**EXHIBIT ONE**

**Table 1**  
**As-Built versus Originally Proposed Structure Locations**  
**Tatanka Transmission Line**

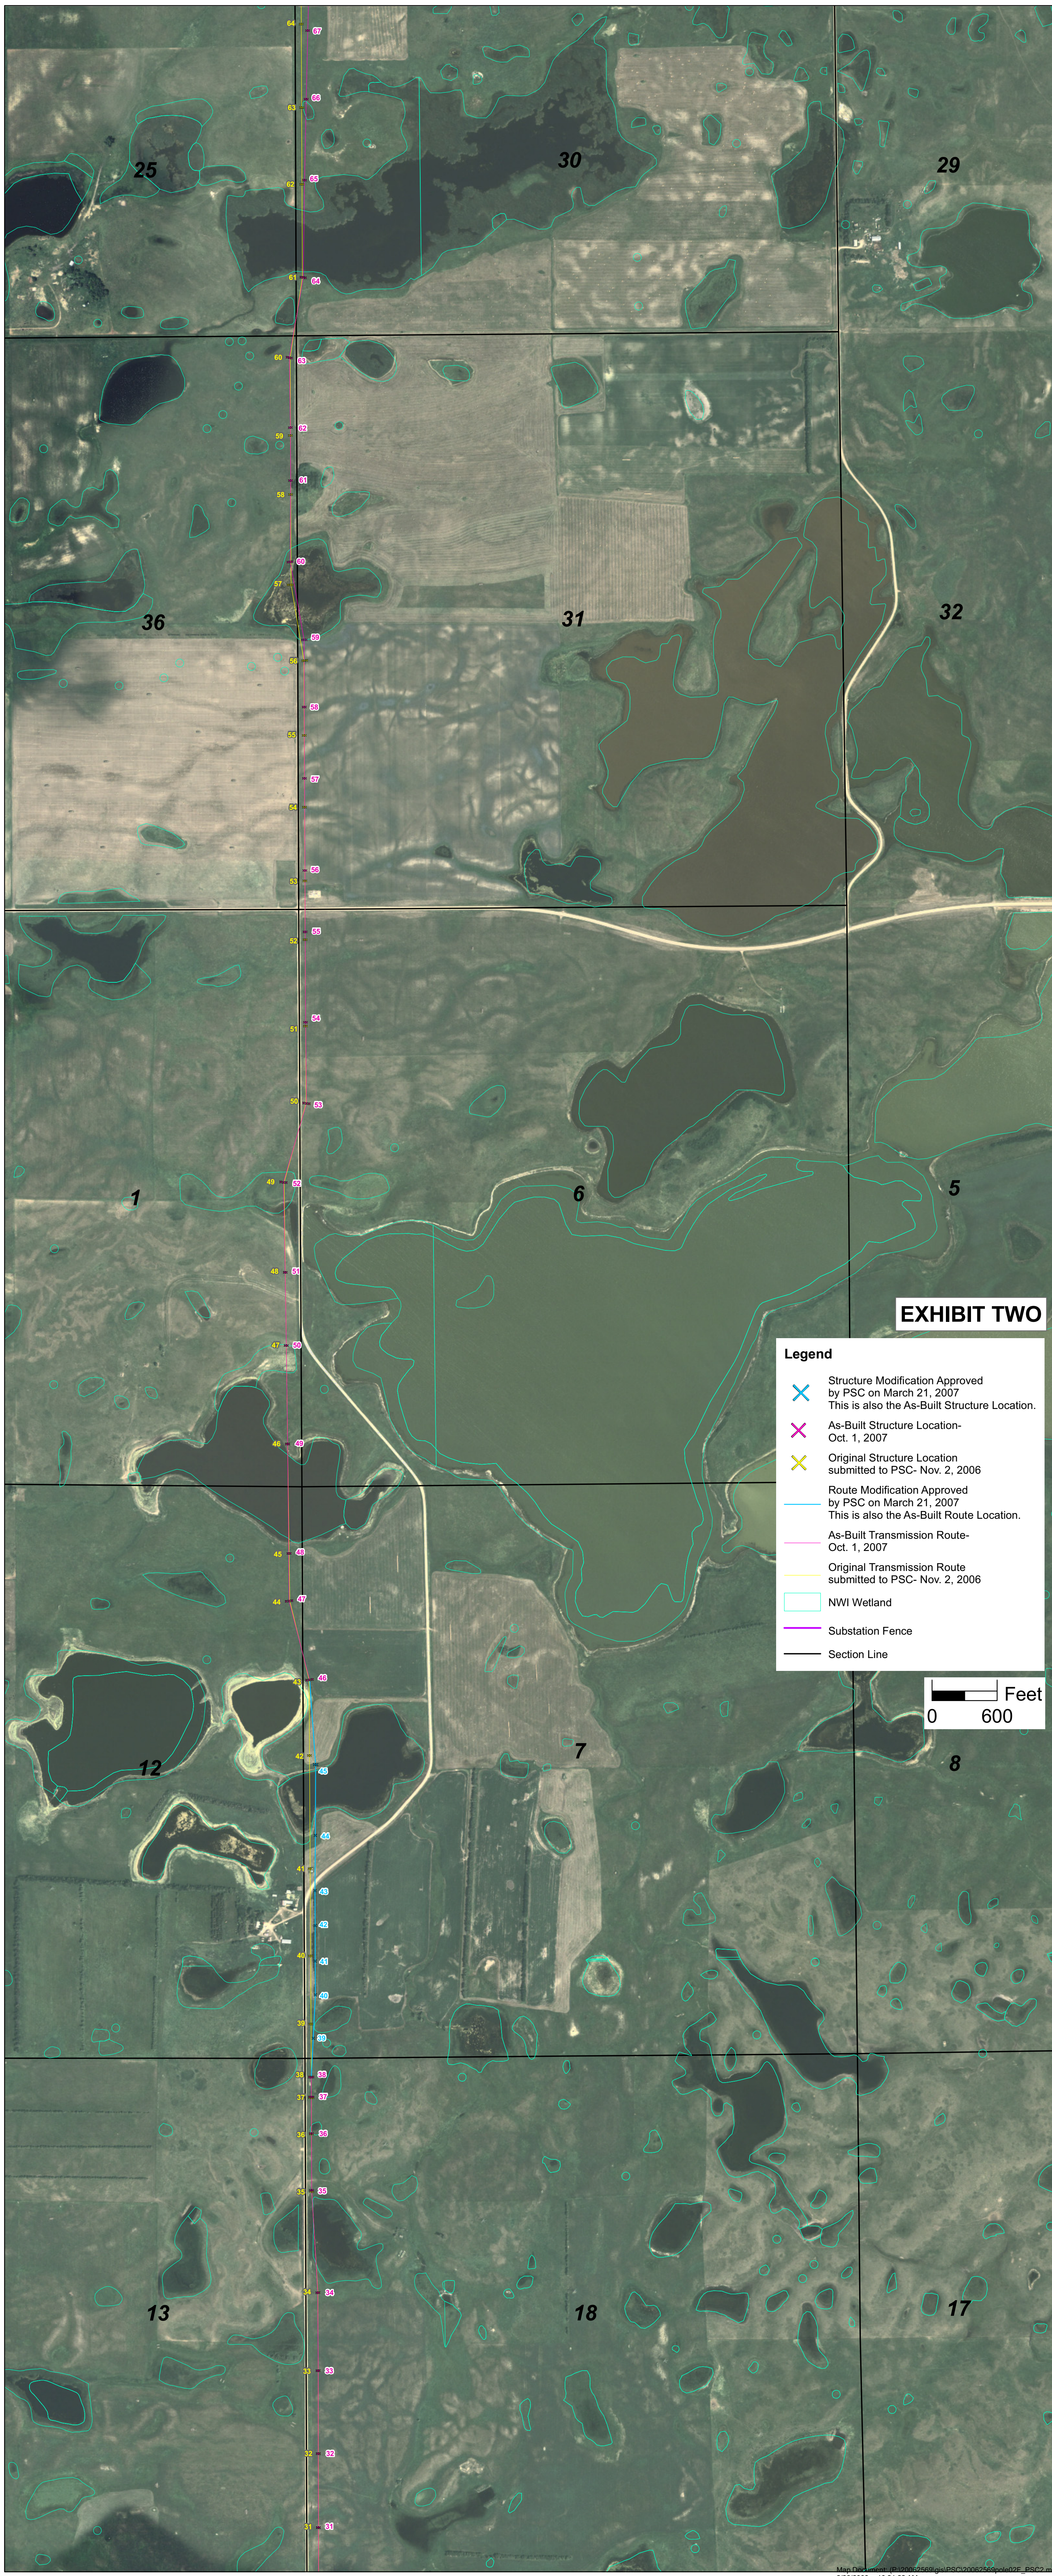
Structure ID	# of Original Proposed Poles	# of As-Built Poles	Approximate Deviation from Proposed Structure	Reason for Change from Original Location
1	1	Not shot	Not surveyed because of switchyard fence barrier	
2	3	3	Structure shifted SE 8.5 ft, 1 pole added 112 ft NE	The structures were routed to go from the Hoffman to Holm property and were crossing over a non-participating landowner's property without having an aerial easement for this design. Structure had to be shifted to accommodate for the new design.
3	3	3	Structure shifted E 84 ft	
4	3	3	Structure shifted S 200ft	
5	2	2	No change	
6	2	2	No change	
7	2	2	No change	
8	2	2	No change	
9	2	2	Structure shifted E 7 ft	Structures shifted to move anchors out of section line road easements.
10	3	3	Structure shifted SE 12 ft	
11	2	2	No change	
12	2	2	No change	
13	3	3	No change	
14	2	2	No change	
15	2	2	No change	
16	2	2	No change	
17	3	3	No change	
18	2	2	No change

19	2	2	No change	
20	3	3	Structure shifted NE 6 ft	Structures shifted to move anchors out of section line road easements.
21	2	2	Structure shifted E 8 ft	
22	2	2	Structure shifted S 13 ft	Was in the section line R.O.W. and had to be moved to be outside.
23	2	2	No change	
24	2	2	No change	
25	2	2	No change	
26	2	2	No change	
27	2	2	No change	
28	2	2	No change

Structure ID	# of Original Proposed Poles	# of As-Built Poles	Approximate Deviation from Proposed Structure	Reason for Change from Original Location
29	2	2	No change	
30	2	2	No change	
31	2	2	No change	
32	2	2	No change	
33	2	2	No change	
34	2	2	No change	
35	2	2	Structure shifted N 12.5 ft	Structure 35 was moved North out of a small pond. Structures 36, 37 & 38 were shifted as a result of that change.
36	2	2	Structure shifted N 4.5 ft	
37	3	3	Structure shifted N 8 ft	
38	3	3	Structure shifted S 3 ft	
39-44	6	6	3 sets of double-pole H-frame structures changed to 6 more closely spaced monopoles. (39) pole shifted S 133 ft (40) pole shifted N 170 ft (41) pole shifted SE 58 ft (42) pole shifted NE 282 ft (43) pole shifted SE 207 ft (44) pole shifted NE 312 ft	Structures 39 through 44 were moved and changed to monopoles to place them as far from a structure owned by Nick Davis as possible while saving trees on the adjacent Barry Holmes property. <b>Note: This modification of the original route was approved by the North Dakota Public Service Commission on March 21, 2007.</b>

**EXHIBIT TWO**

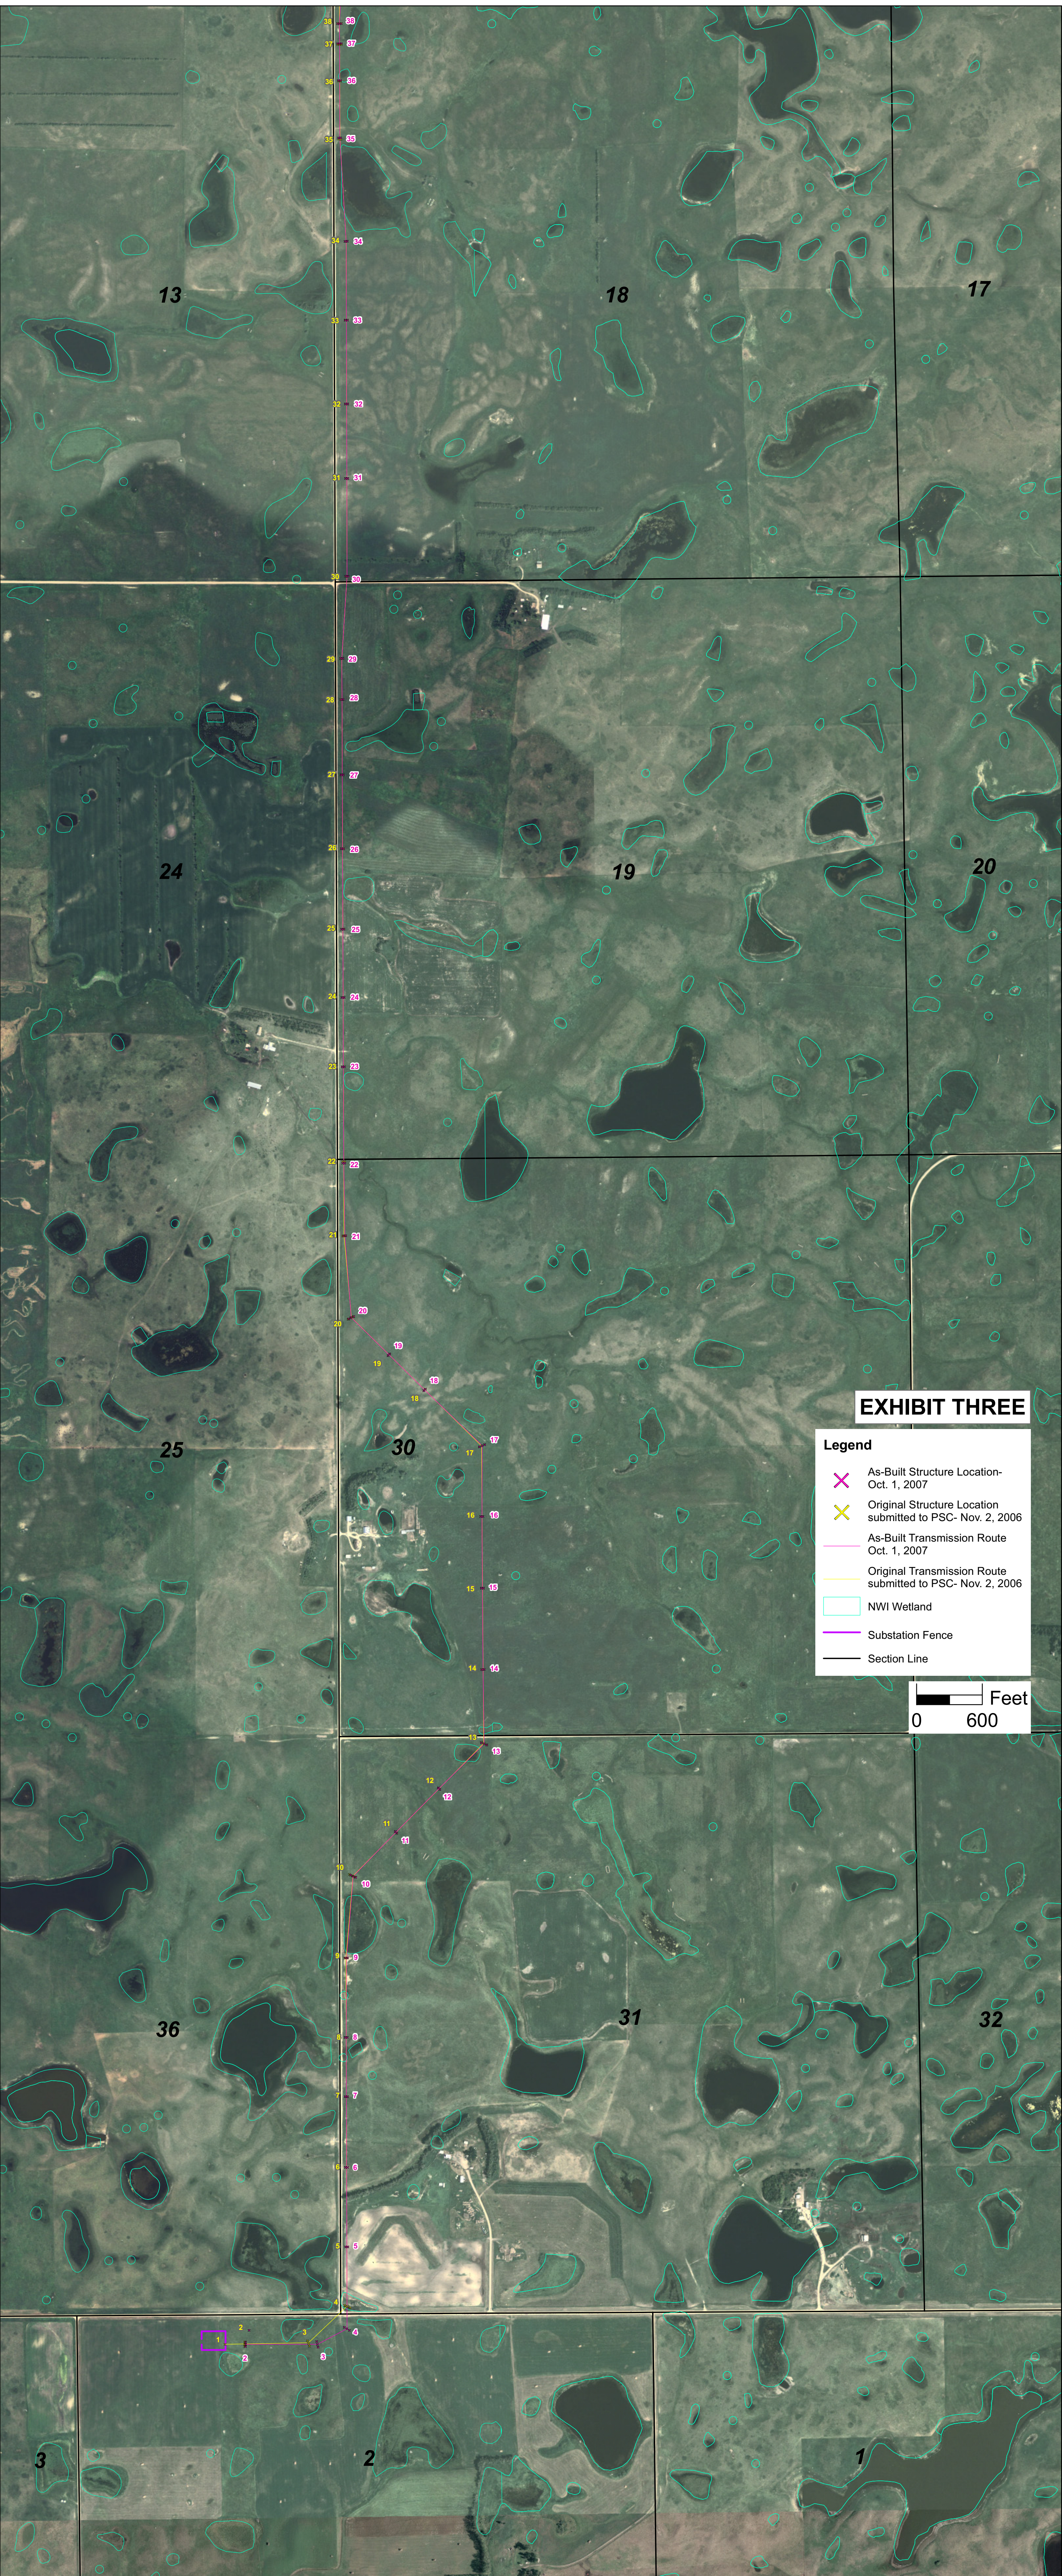
45	2	2	Structure shifted SE 100 ft	Structure 45 was moved for same reason as structures 39 through 44. <b>Note: This modification of the original route was approved by the North Dakota Public Service Commission on March 21, 2007.</b>
46	3	3	No change	
47	3	3	No change	
48	2	2	No change	
49	2	2	No change	
50	2	2	No change	
51	2	2	No change	
52	3	3	No change	
53	3	3	No change	
54	2	2	Structure shifted N 34 ft	The line was crossing over non-participating landowner's property (between structures 59 & 60) without having an aerial easement for this design. Structures had to be shifted to accommodate for the new design which allowed overhang on the landowner to the North East.
55	2	2	Structure shifted N 71 ft	
56	2	2	Structure shifted N 97 ft	
57	2	2	Structure shifted N 266 ft	
58	2	2	Structure shifted N 261 ft	
59	3	3	Structure shifted N 192 ft
